# PCN – Product Change Notification

Document No	PCN-A-080602	Revision	1.0		
-------------	--------------	----------	-----	--	--

**ECN Topic: New 8.4 inches Rear Mount Dimension**

**New Mechanical Dimension:**

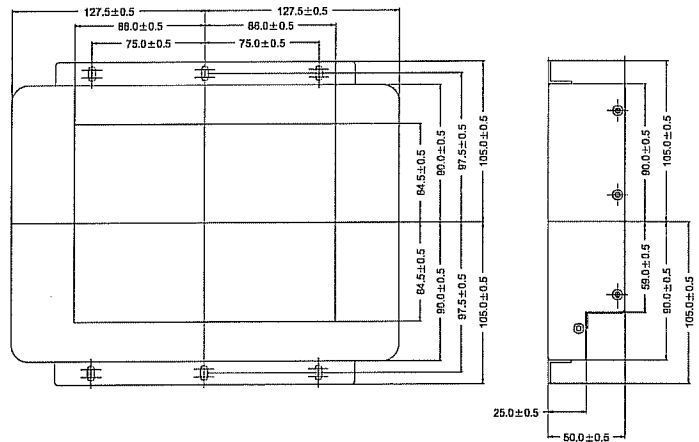
We will release new dimension for 8.4" Rear Mount LCD. The dimension of mechanical will change from 230 x 180 x 45 mm to 255 x 180 x 50 mm and change the position of OSD to the back side.
